City of Talent

STAFF REPORT

Date: May 5, 2015
Item: SPR 2015-003, Ian Bagshaw
Site: 550 S. Pacific Hwy.

Requested Action: Approval of a Site Development Plan to modify parking on a commercial parcel to provide a permanent location specifically for mobile food vendors and create additional parking stalls using pre-existing paved surfaces.

PROPOSAL

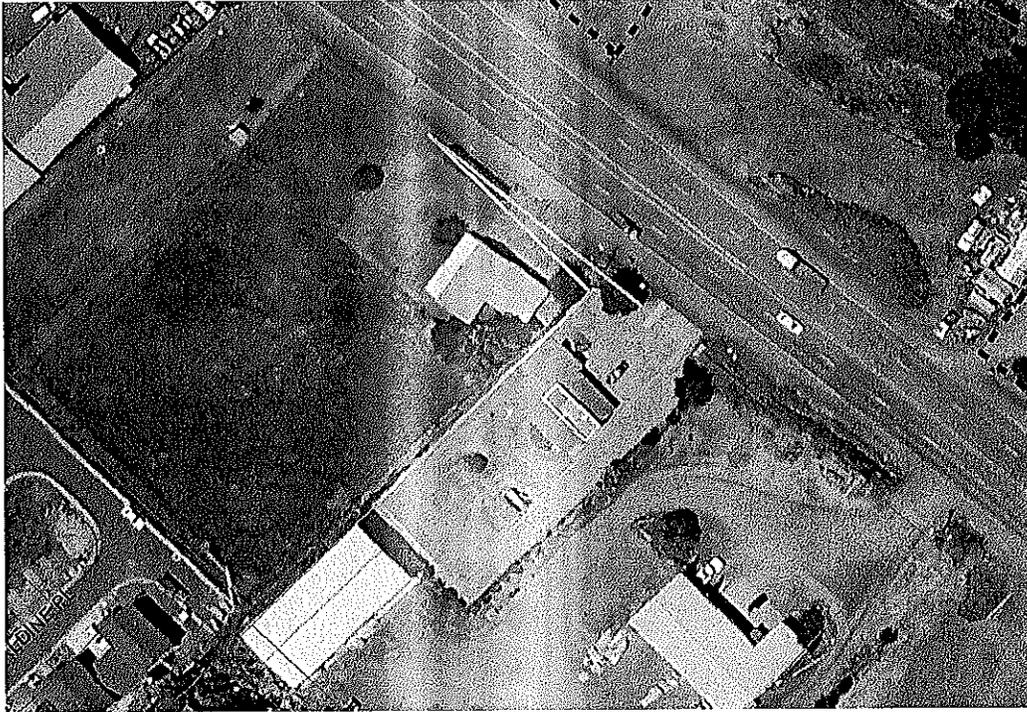
Parking stall angles are identified on the site plans, however stall and aisle dimensions are not. As a condition of approval, the applicant shall adhere to the minimum parking space and aisle dimensions as identified in Table 570-1 of the Talent Zoning Code. **The provisions of this section have been met subject to conditions of approval.**

FINDING: The proposed plan identifies each space however a site visit had indicated that parking stall lines have faded substantially in the decades since the lot was initially paved and marked. As a condition of approval, the applicant shall permanently and clearly mark the parking area as detailed on the approved plan. **The provisions of this section have been met subject to conditions of approval.**

FINDING: The proposed site plan does not identify wheel stops for the parking stalls abutting the exterior of the building. To ensure the safety of pedestrians using the sidewalk adjacent to the building and those within the building, the applicant shall, prior to mobile food cart occupancy on-site, install wheel stops in the parking stalls that abut the building. **The provisions of this section have been met subject to conditions of approval.**

1. The applicant shall continue to maintain existing landscaping, fences, walls and signs.
2. The applicant shall continue to maintain no less than two (2) bicycle parking spaces in a safe and practical location.
3. The applicant shall adhere to the minimum parking space and aisle dimensions as identified in Table 570-1 of the Talent Zoning Code.

4. The applicant shall re-stripe the ADA Van Accessible parking stall and bring it into conformance with current ADA requirements.
5. The applicant shall permanently and clearly mark the parking area as detailed on the approved plan.
6. The applicant shall install wheel stops in the parking stalls that abut the building.
